Swanwick Airspace Improvement Programme
Airspace Development 5
Proposed changes to LAC West to improve ATS route connectivity

SAIP AD5
Documentation:
Stage 4 Update and Submit

Step 4A Update Design

Figure 6: Final proposal - Routes and CAS associated with Birmingham and Heathrow

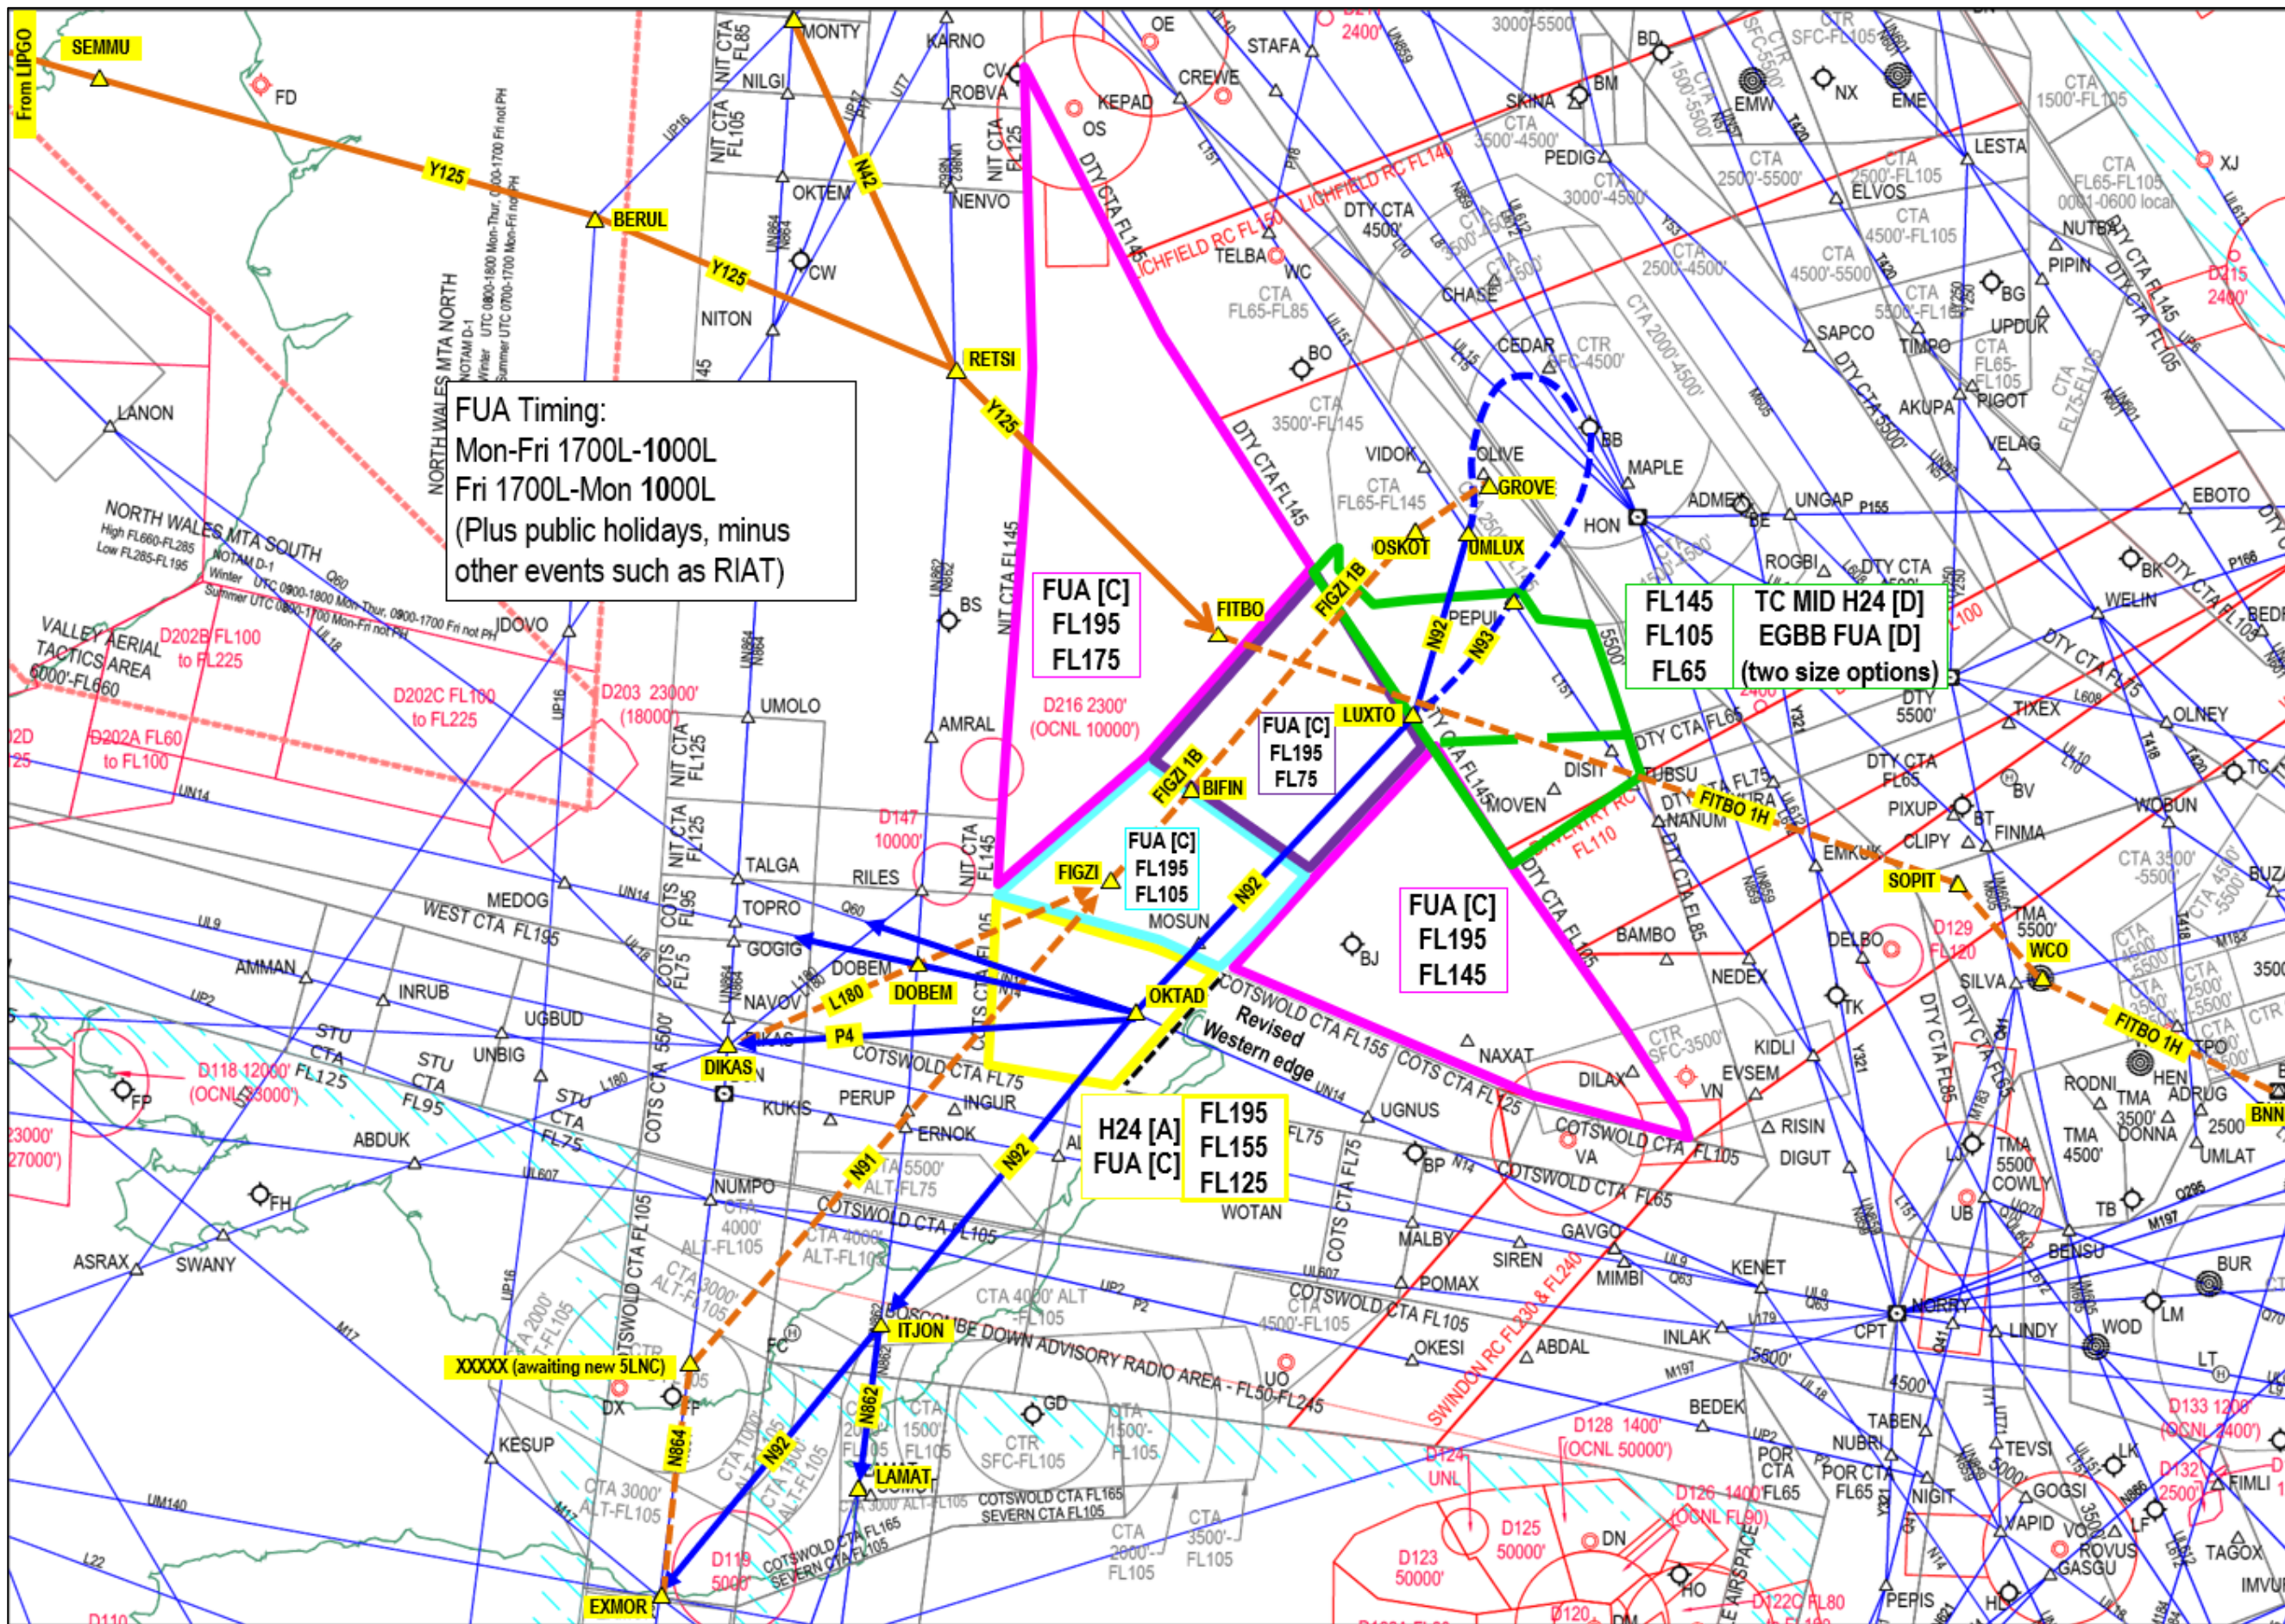
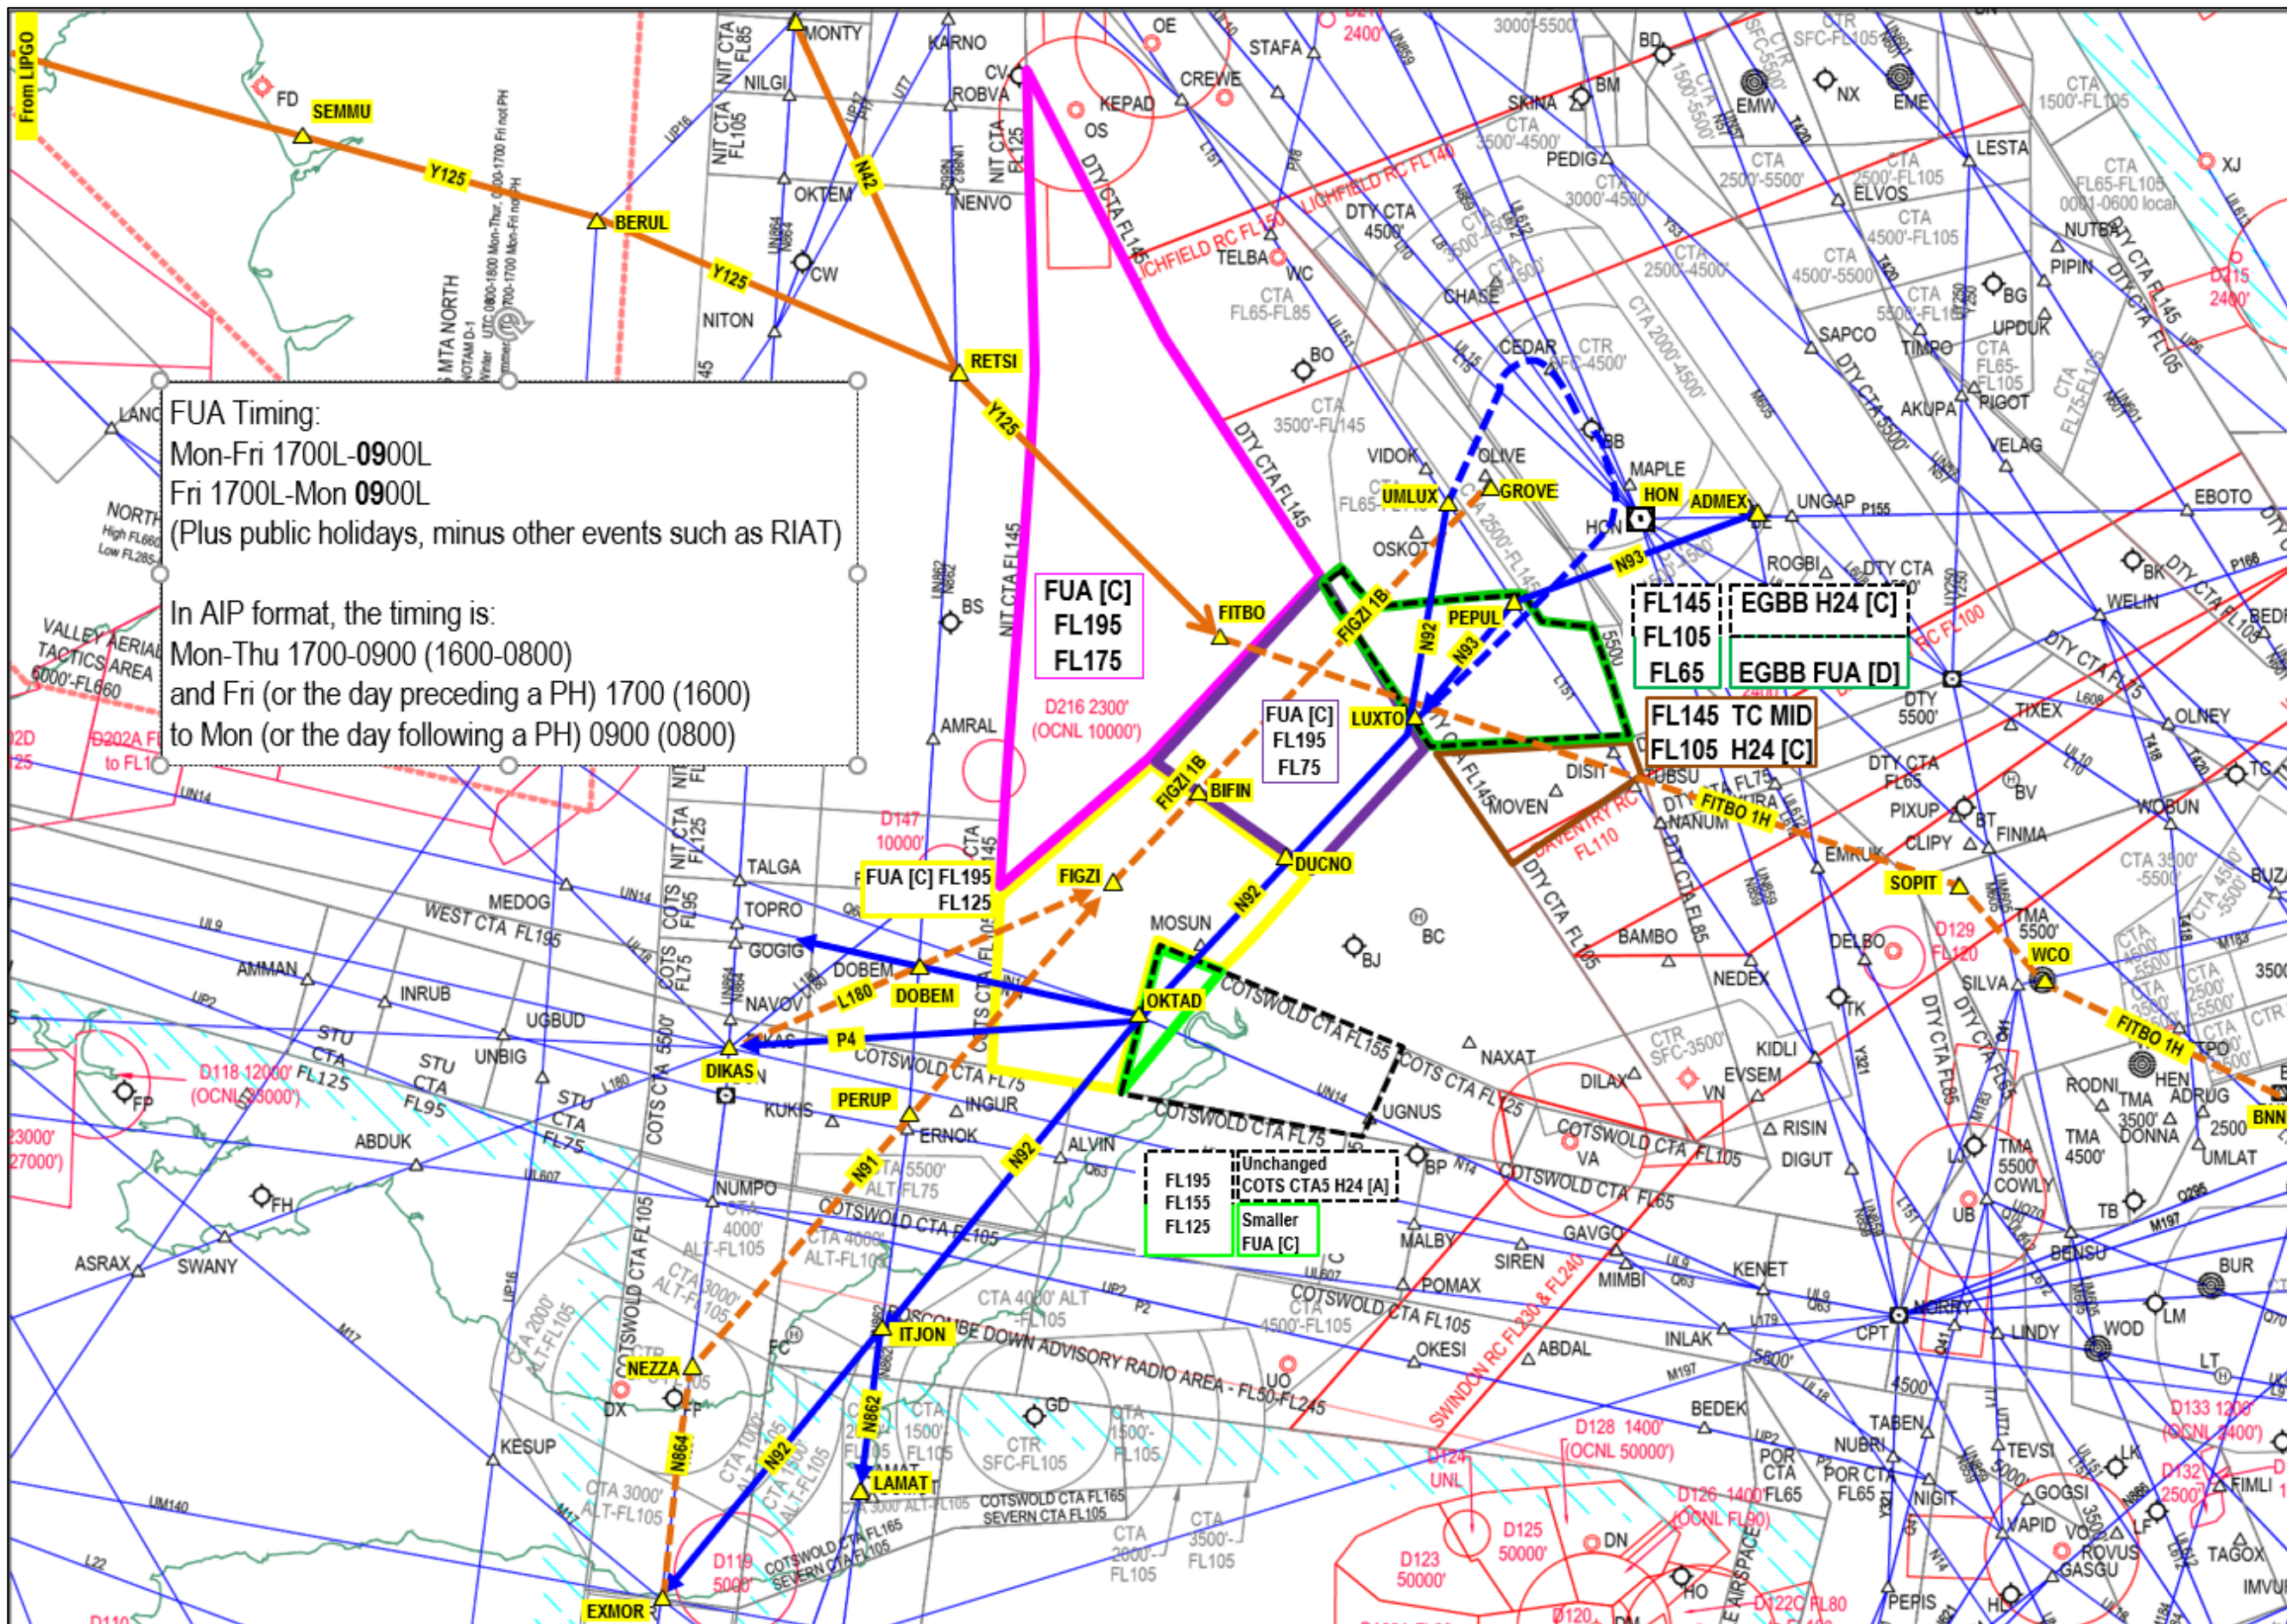
The figures on the next pages allow a comparison between the consulted-upon schematics of how each traffic flow will be handled, and the post-consultation final design with these changes illustrated (including charts illustrating the changes in high level ATS routes discussed under para 3.7 above).

Figure 7 Q60 westbound KOPUL UGNUS as consulted upon (top) and final proposal (above) allowing intersection with eastbound L179 traffic – see para 3.7.1

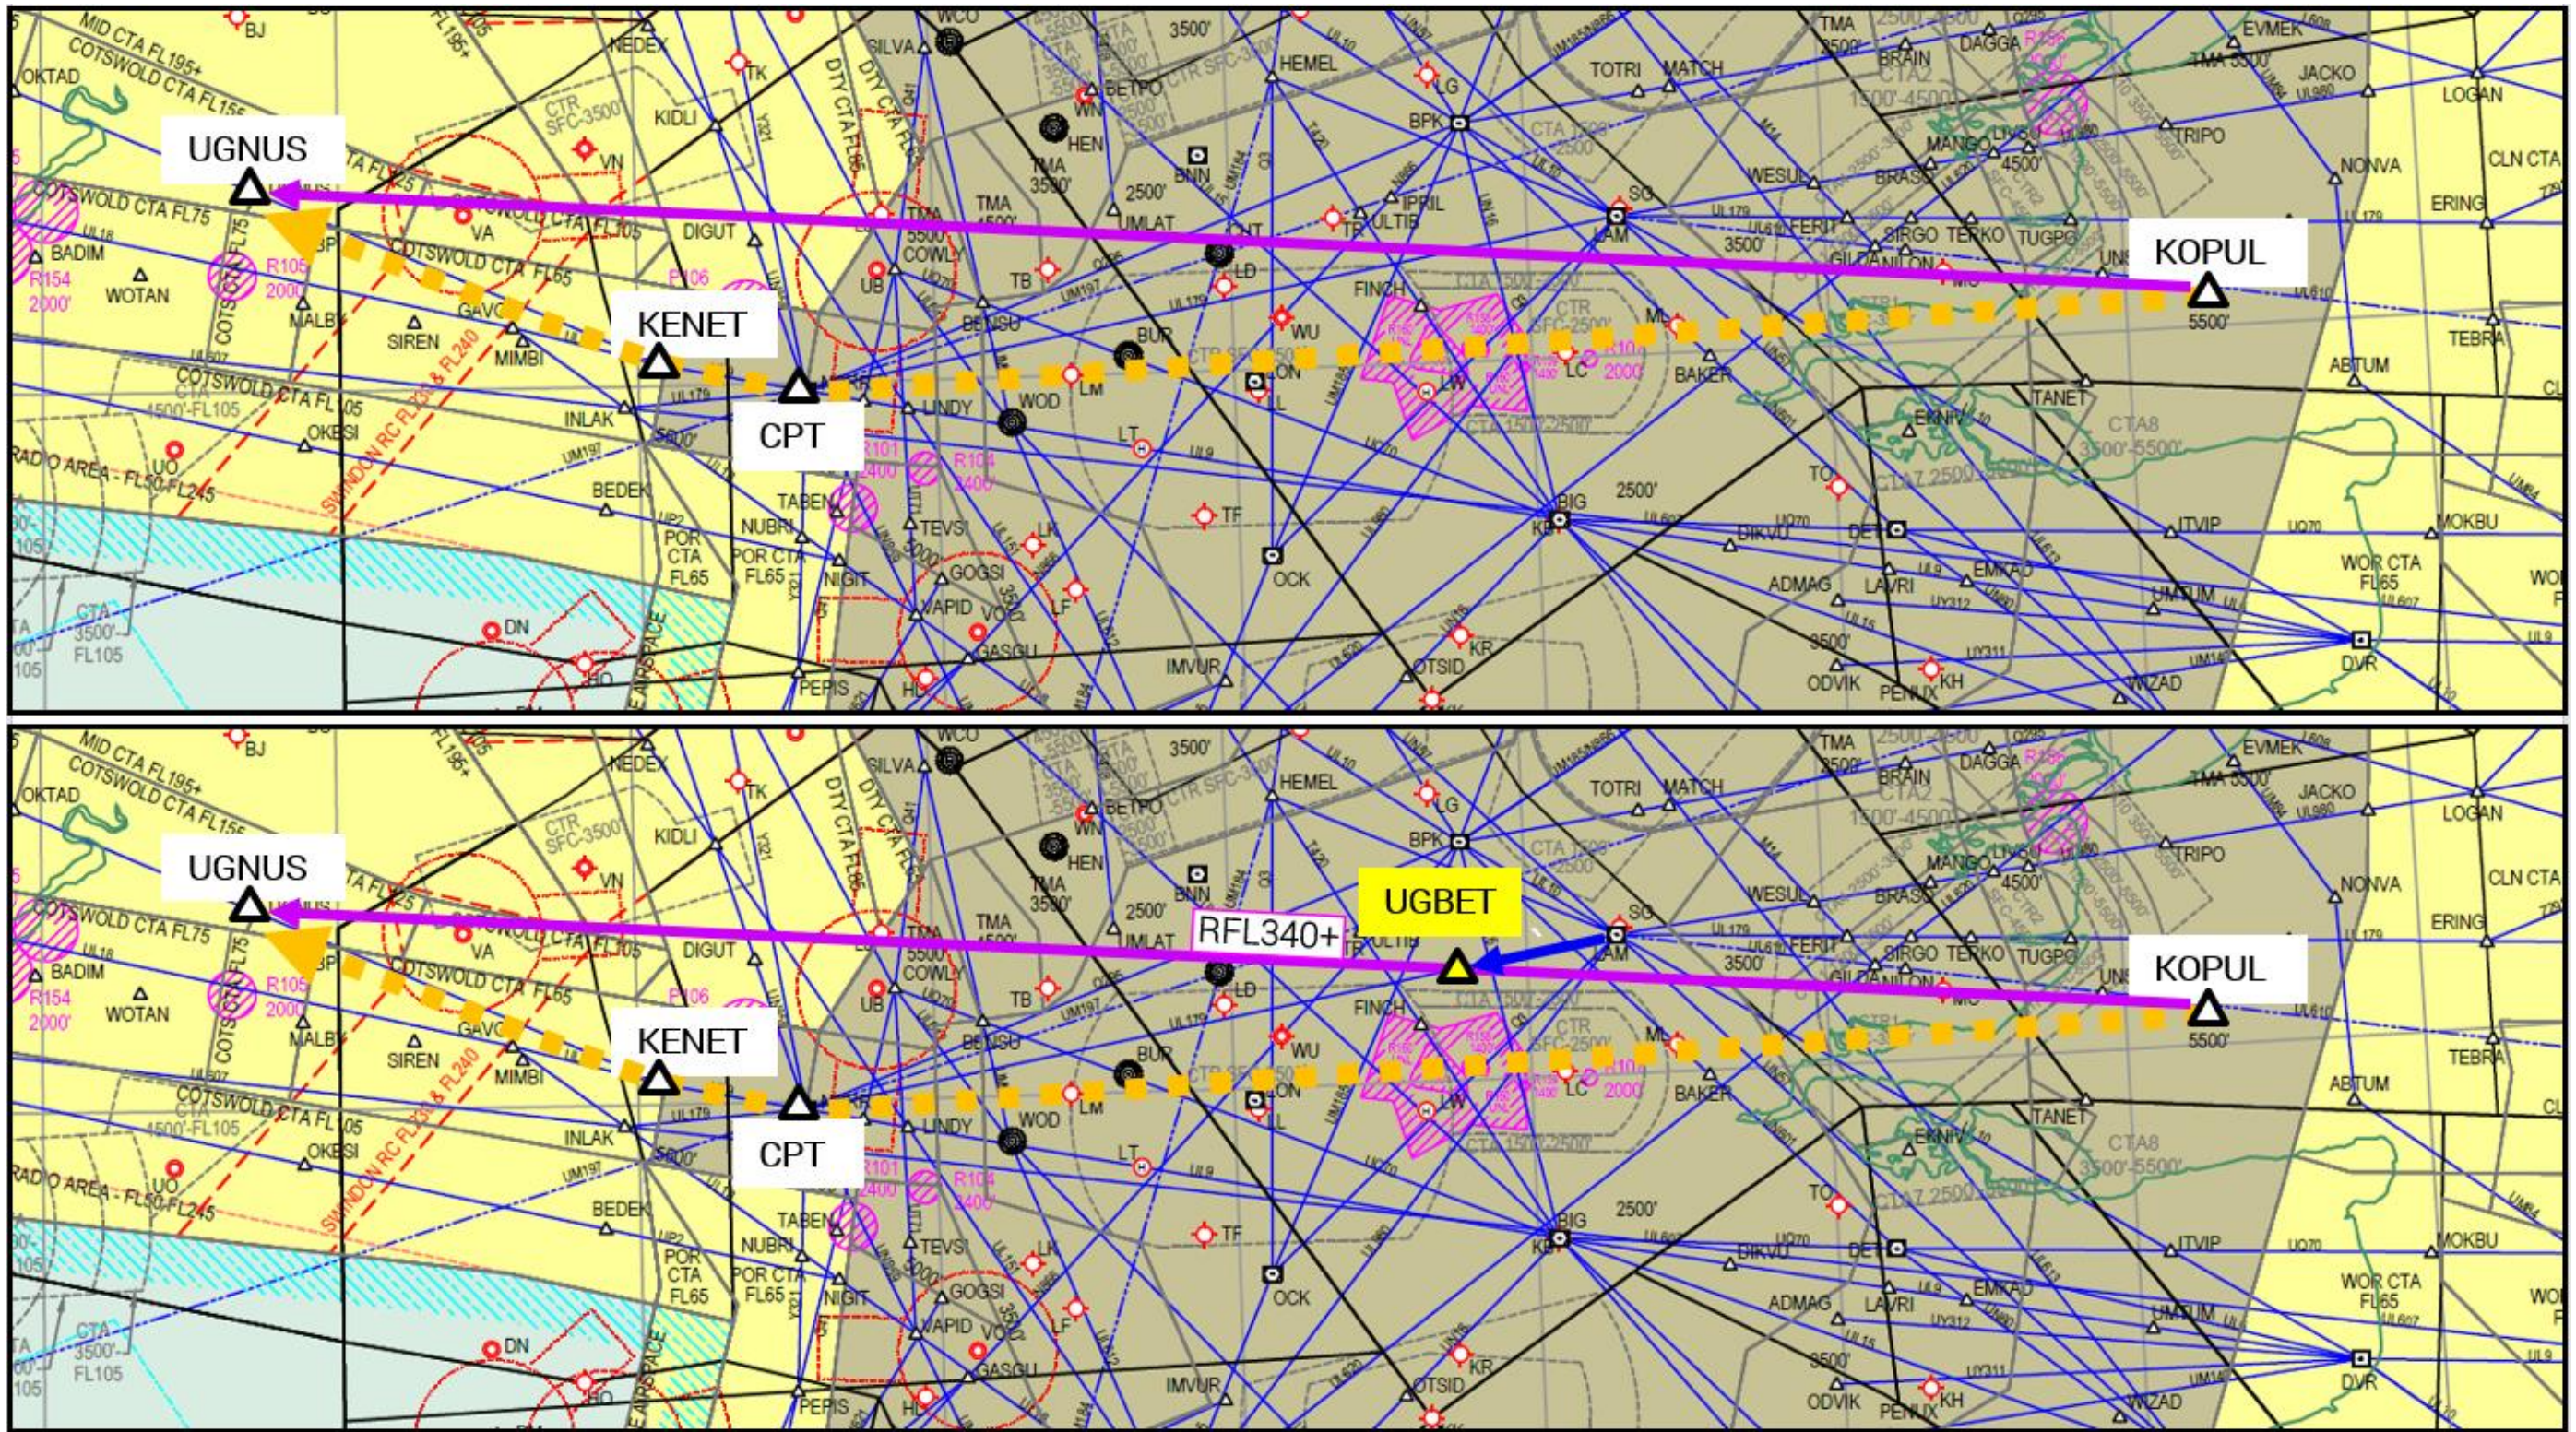
Consultation document Figure 8, this document Figure 7 on page 15.

New waypoint UGBET added to create intersection with extant L179 west of LAM – captures more eligible traffic using L179 westbound, onto a shorter route for DIKAS further west. Clarification of minimum RFL340 to avoid interaction with MTMA departures in S24.
